Supplements to Exhibits 1, 3, 5, and 7

Re-opened Hearing: Petition No. 2013-0250

Presented to the Capital Region-Syracuse Board of Review

Jonathan Ochshorn (petitioner)

Figure 1. Occupancy sign in Crit Room dated July 22, 2013.

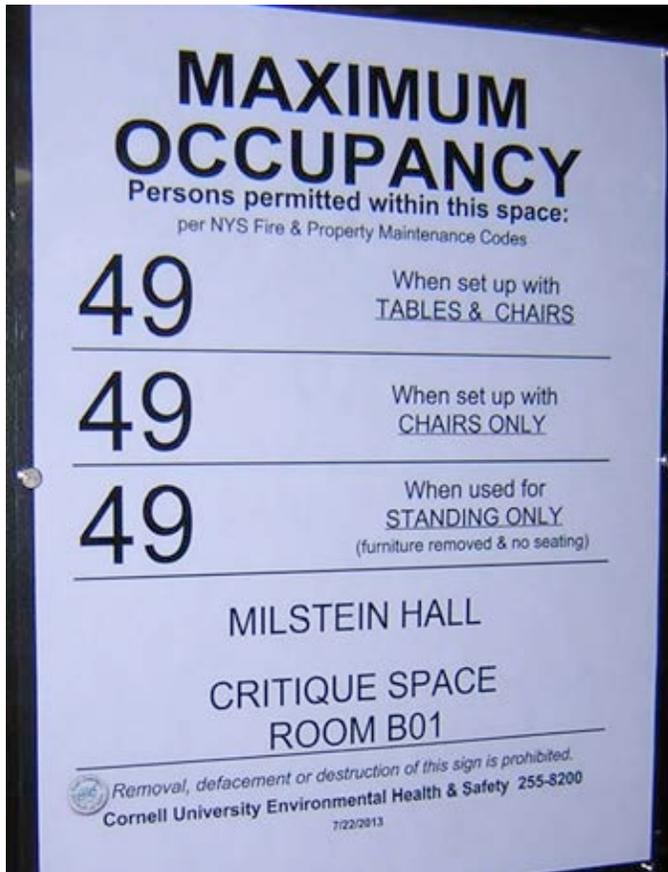
1. Cornell has already violated the findings of the Board concerning Exhibit 1, by placing a sign in the Crit Room space limiting occupancy to 49 persons (see Figure 1). The Hearing Board sustained my claim that a single exit is noncompliant and, in sustaining the appeal, implicitly supported the remedies I outlined:

Cornell has used the “third approach” that is expressly forbidden in Exhibit 1 (and that is expressly forbidden by the 2002 NYS Building Code) by posting an occupancy sign that does not even come close to representing the maximum calculated occupant load for the space.

Figure 3. Plan of the auditorium and crit room showing multiple and prominent connections between the two spaces.

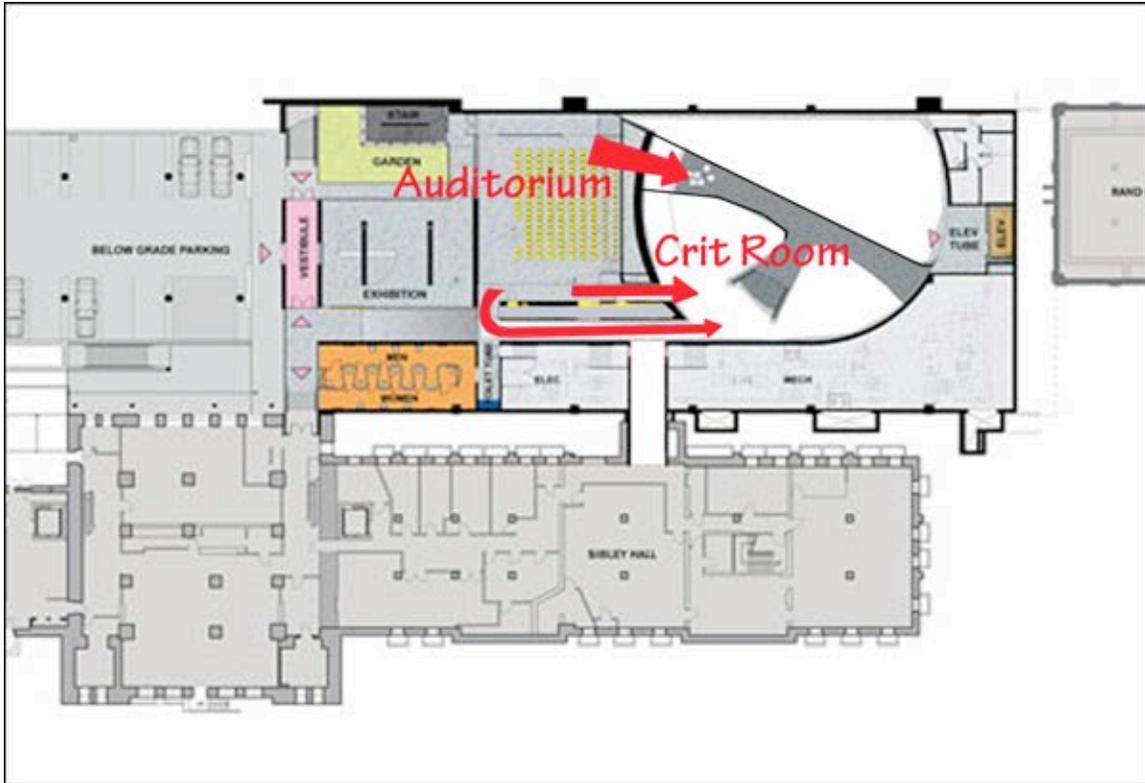
3. Moreover, the Crit Room space was initially permitted for assembly (exhibition, reception, etc.) as well as classroom use. It's use as an assembly space for reception and exhibitions is absolutely central to the building's conception and operation. Cornell describes the space as follows: "The double-height space in the lower level, created under the dome, **is the center of Milstein Hall — a multi-use space** for students and faculty. **The bridge links the main public entry of Milstein Hall to the auditorium** and the lower plate." The Crit Room was, and is, directly connected to the Milstein Hall auditorium and will still function as a reception and/or exhibition space for large events, such as lectures, since the hundreds of people attending events in the auditorium are able to *move directly into the adjacent Crit Room space* through two prominent glass doors (Figure 2 and Figure 3). Additionally, a lower-level exit from the auditorium leads into the corridor that connects directly to the Crit Room space. This space was, and is, configured for reception and exhibition events, since it is directly and prominently connected to the auditorium, and it is both dangerous and unrealistic to pretend that such events will never again occur in the space.

The Crit Room was, and is, a room with more than 4,500 square feet of area and only a single compliant exit. Posting a sign limiting occupancy to 49 persons is not consistent with the requirements of the New York State Building Code. I request that the Board clarify its findings with respect to this Exhibit, and address Cornell's continued occupation of the space with only a single exit.

Figure 4. Ground floor plan shows that *fire barrier protection is needed between Milstein and Sibley Halls, not "exterior wall" protection*. Covered areas count as building area, per Section 502.1 of the New York State Building Code.

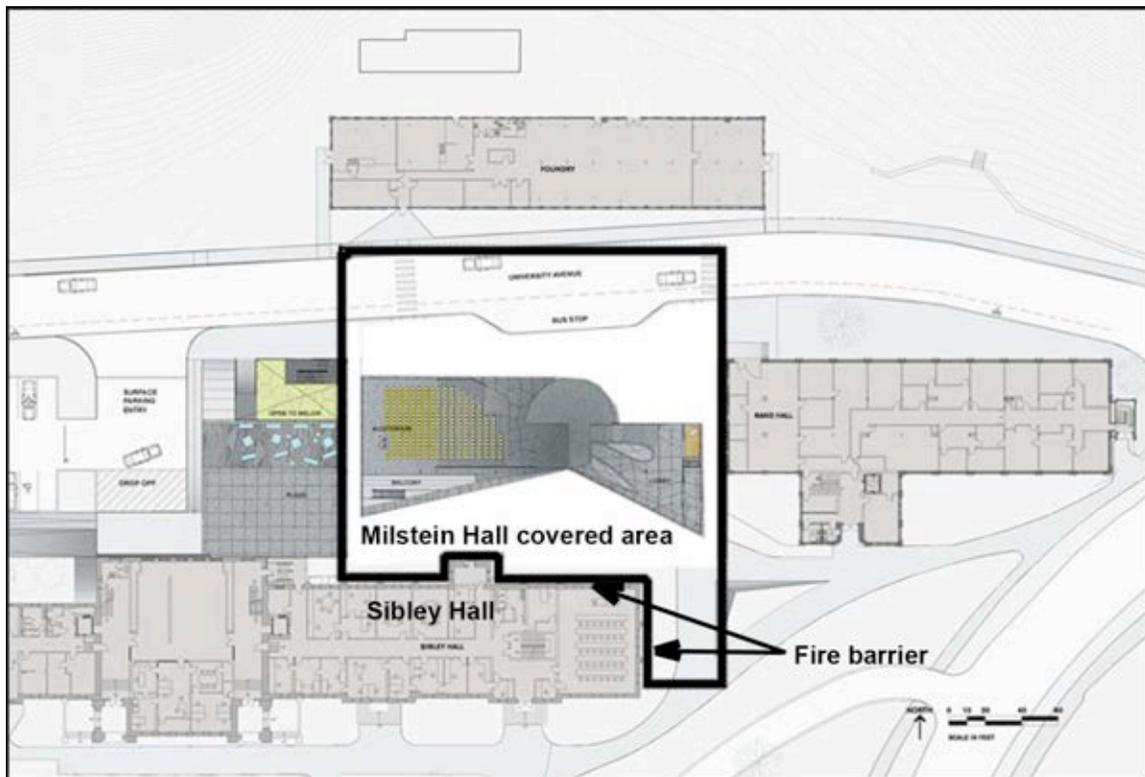
Even though the first floor and basement windows in Sibley are technically in "exterior walls," these exterior walls are not required to be "rated for protection" (Figure 4). Table 601 in the Building Code has *no exterior bearing wall fire-resistance rating requirement* for Type V-B construction, except as may be required by Table 602. However, Table 602 only requires fire-resistance ratings for exterior walls closer than 30 feet to the closest interior lot line, or centerline of a street. None of this one-sided exterior wall protection applies to the wall between Milstein and Sibley Hall, which instead must be designed to *separate two building areas*, one of which is the covered exterior building area under the upper level of Milstein Hall.

This covered exterior area counts as building area per Section 502.1 of the Building Code, which defines *Building Area* as follows: "...Areas of the building not provided with surrounding walls shall be included in the building area if such areas are **included within the horizontal projection of the roof of floor above**" (emphasis added). The overhanging second floor of Milstein Hall therefore creates "building area" in all the covered spaces below.

In other words, since fire barriers are required to separate portions of the building between this covered area of Milstein Hall and the first and basement levels of Sibley Hall, then the sprinklers at those locations should correspond to the use of fire barriers at those levels. That fire barriers were installed at these locations means they are *separating building areas* on both sides (otherwise they would not be required); hence the sprinklers *should be on both sides* of the fire-rated glazing.

Therefore, the double-sided application seems correct, and the single-sided application actually used appears to be noncompliant.

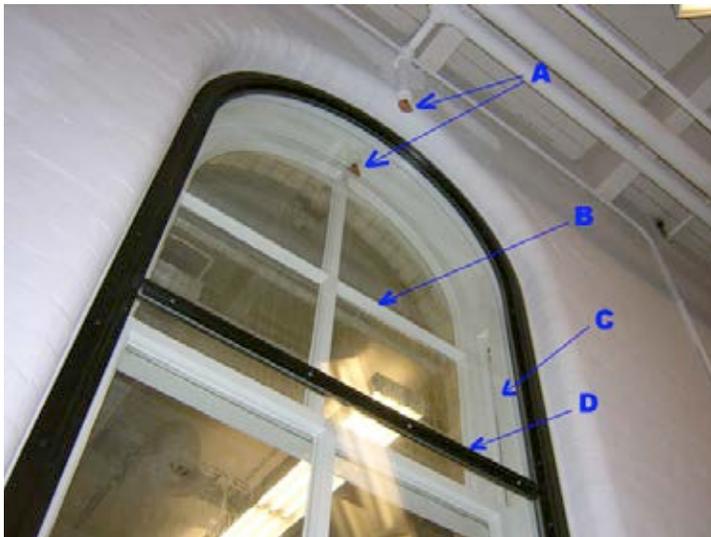
There are four items marked on the photo, and I wish to get your evaluation or comments on each of them: specifically, based on the information I have provided, do they conform to the requirements of ESR-2397 or NER-516.

Item A shows the two vertical sidewall sprinklers. One of the two sprinklers is sandwiched between the new fire-rated glazing (in the black metal frame) and the existing window. This "inside" sprinkler is *less than 4 inches from the face of the fire-rated glazing*.

Item B shows the existing wood-framed window in this installation. The "inside" sprinkler described in Item A is *sandwiched between the existing window and the new fire-rated glazing*.

Item C shows the wood (combustible) frame of the existing window, which is *less than 2 inches from the fire-rated glazing*.

Item D shows a *horizontal mullion* (or muntin) that projects out from the face of the fire-rated glazing more than 5/8 inch.

You have stated that the inside vertical WS sprinkler is less than 4 inches from the inside face of glass. The UL Listing requires a minimum of 4" from the face of glass. We have not performed testing at distances less than 4 inches to my knowledge and therefore cannot speculate on the impact of the distribution of water onto the glazing. There appears to be a horizontal mullion running across this new pane of glass. Horizontal mullions are not allowed in accordance with the UL Specific Application Listing.

You have stated that the wood framing from the original window is less than 2" from the new glazing. The UL Listing requires that all combustible material must be a minimum 2" from the face of glazing.

With regard to the WS sprinkler on the other side (outside) of the newer glazing, I have the following comment. You have stated that there is a horizontal mullion projecting more than 5/8" from the glazing. It is likely that this horizontal mullion would impede the smooth continuous flow of water down the glazing and create unacceptable dry spots. Again, horizontal mullions are not allowed in accordance with the UL Specific Application Listing.

Lastly, this installation is quite unique in nature as it encompasses a "new" piece of glazing located off of an existing window, resulting in an "enclosed" area between two pieces of glazing where one of the two WS sprinklers is located within. This arrangement was not considered in the UL testing nor is it addressed within the evaluation service reports. It should be understood that the intent of the WS Window Sprinkler is to realize activation in a timely enough manner to protect the associated glazing. The existence of two panes of glass on either side of the one WS sprinkler will result in the prevention of hot gasses to that sprinkler until such time that the original pane may rupture. Consideration should be given to what will happen to the rupturing pieces or sections of glass. Could large pieces somehow be propped up against the newer pane, causing an obstruction to the smooth flow of water down this pane?

In conclusion, this installation does not appear to be in compliance with the UL Listing per Tyco data sheet TFP620, ESR-2397 or NER-516

Figure 5. Approximate floor areas of Milstein, East Sibley, and Rand Halls. Milstein Hall's actual upper-floor area is 25,600 square feet, according to "Issued for Construction" permit drawings dated Dec. 5, 2008.

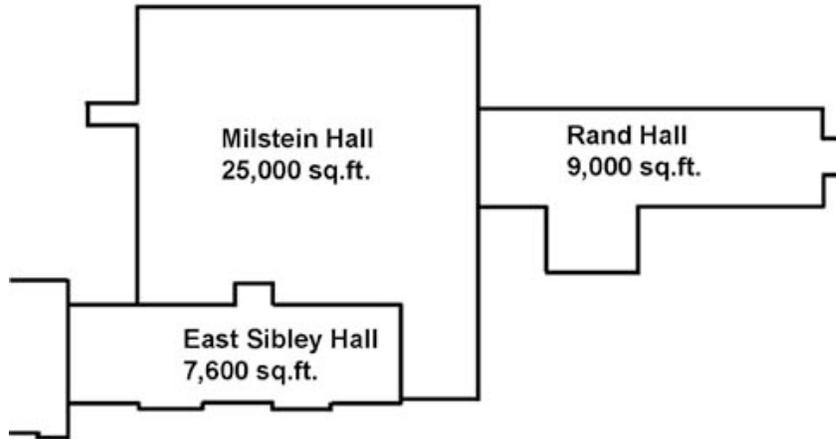
Since Milstein Hall — considered by itself without the added area of Sibley or Rand Halls — *still exceeds area limits* specified in Table 503 of the NYS Building Code, it is clearly noncompliant. This is because Table 503 of the Code sets a per-floor area limit for nonseparated B/A-3

occupancies with Type V-B construction of 6000 square feet, which can be increased to no more than 22,500 square feet when sprinklers and the *maximum* possible frontage allowances are factored in (Milstein Hall's allowable area is actually even lower than 22,500 square feet when the *calculated* area increase due to frontage is used). Because Milstein Hall has a per-floor area of 25,600 square feet, it exceeds this limit and is therefore noncompliant (Figure 5).

Given the apparent inconsistency between the Hearing Board's decision supporting the code enforcement official's interpretation of Appendix K, and the noncompliant floor area of Milstein Hall (even when the allowances of Appendix K are accounted for), I request clarification as to the compliance of Milstein-Sibley-Rand Hall with respect to Table 503 floor areas limits.

Figure 6. Plan of E. Sibley Hall, 2nd floor, from Cornell's handout.

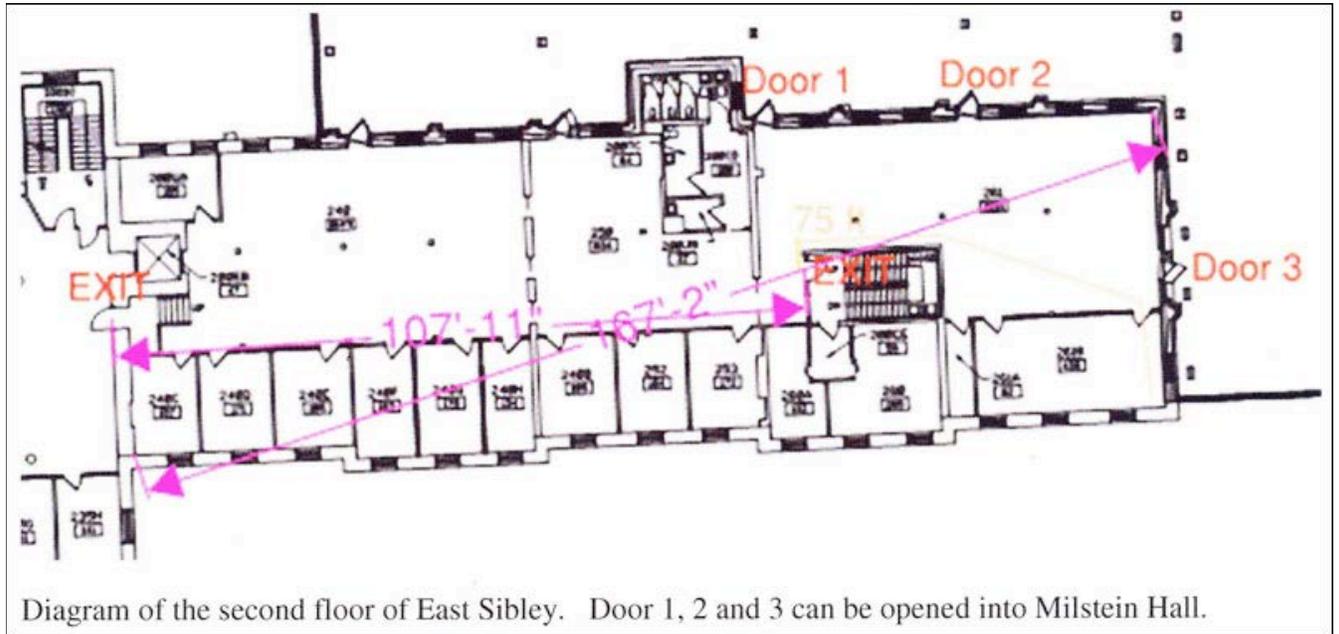
1. It is absolutely inappropriate and dangerous to compute the remoteness of exits within a room or area by looking only at the remoteness of exits for the building as a whole. The plan provided in Cornell's handout (Figure 6) shows only the remoteness calculation for East Sibley Hall as a whole, but not for Room 261. The idea that this room "is part of a larger space with two remote exits," and therefore does not need to satisfy exit requirements for its own occupancy, is so completely wrong-headed and dangerous that I find it hard to believe that such statements would be put in writing by both the architect of record and the architect managing the project for Cornell.

2. The caption under Cornell's plan (Figure 6), further states that "Door 1, 2, and 3 can be opened into Milstein Hall." First, this is factually inaccurate, as these doors are often locked when the room is occupied. Second, having doors that "can be opened" is not a sufficient specification for a legal exit. For one thing, there are no exit signs marking these doors as exits; and there is no special hardware that guarantees that the doors remain unlocked (in fact, as I have just written, the opposite is true).

6. Even if this space is newly permitted as a Group B space for educational occupancies above the 12th grade level, it is important to note that there is already a large, 390 square foot seminar room with capacity for approximately 25 persons that exits through this room (shown in Figure 6); therefore, **only 24 additional occupants (i.e., 49 minus the number of occupants in the seminar room) can legally occupy 261 E. Sibley Hall**, and the occupancy sign should correspond to that limit of 24 occupants. The *total* limit of 49 occupants (25 + 24) applies to the combined space of 261 East Sibley Hall and its seminar room (261B East Sibley Hall) because there is only a single compliant exit. Per New York State *Code Interpretation 2008-01*, even a prior legal occupancy of these spaces with more than 49 occupants could not continue under the current Code — that is, could not be "grandfathered." In fact, prior occupancies of the space did not exceed 49 occupants (library stack area from 1974 – 2011; design studio classrooms 1959 – 1974), so the question of a "grandfathered" occupation for more than 49 persons is moot in any

Figure 7. Occupancy signs for Room 261 E. Sibley Hall photographed in July, 2013 (left) and in May, 2012 (right).

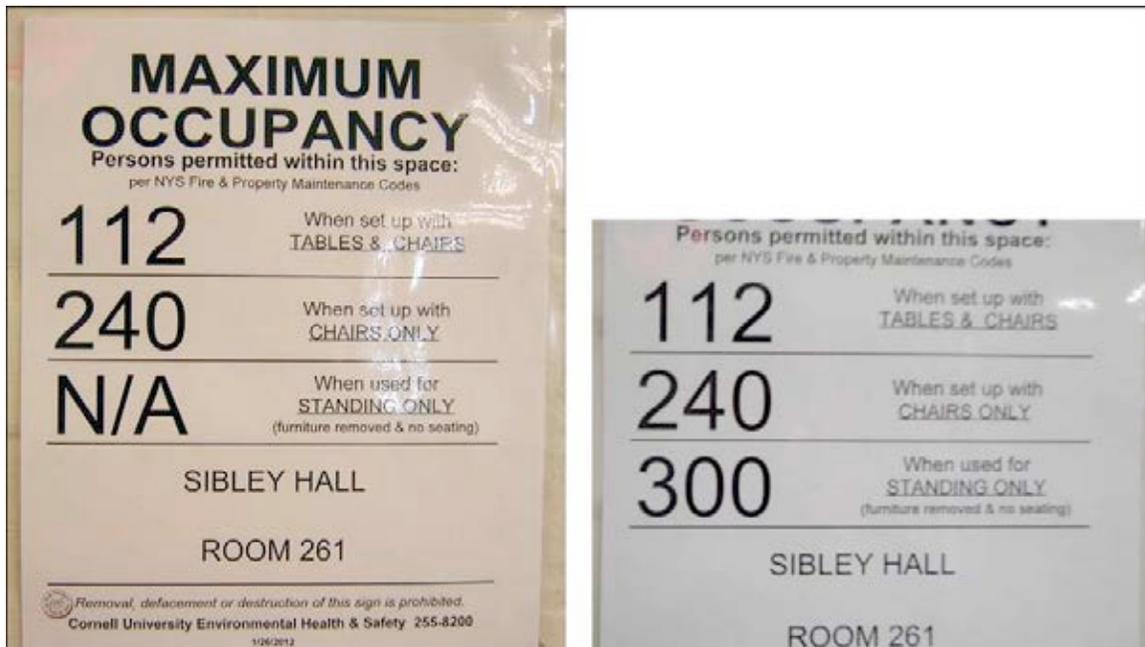
In fact, the posted occupancy sign in Room 261 was not only recently created, but it was revised at least twice within the past year or so — well after Milstein Hall was completed (Figure 7).

As this occupancy sign was edited and re-posted after May 9, 2012, it is clearly something done deliberately — well after the certificate of occupancy for Milstein Hall was issued on Feb. 24, 2012. It therefore **should have triggered a code review under the Existing Building Code of NYS**, since all changes of occupancy — even those within the same A-3 occupancy class — require Code review. Increasing the occupancy of a space from 100 square feet per occupant to 7 square feet per occupant, and thereby increasing the occupant load in the room from 17 to 300 (subsequently changed to 240) clearly is something that the Building Department should have reviewed, especially in a space with only a single legal exit.
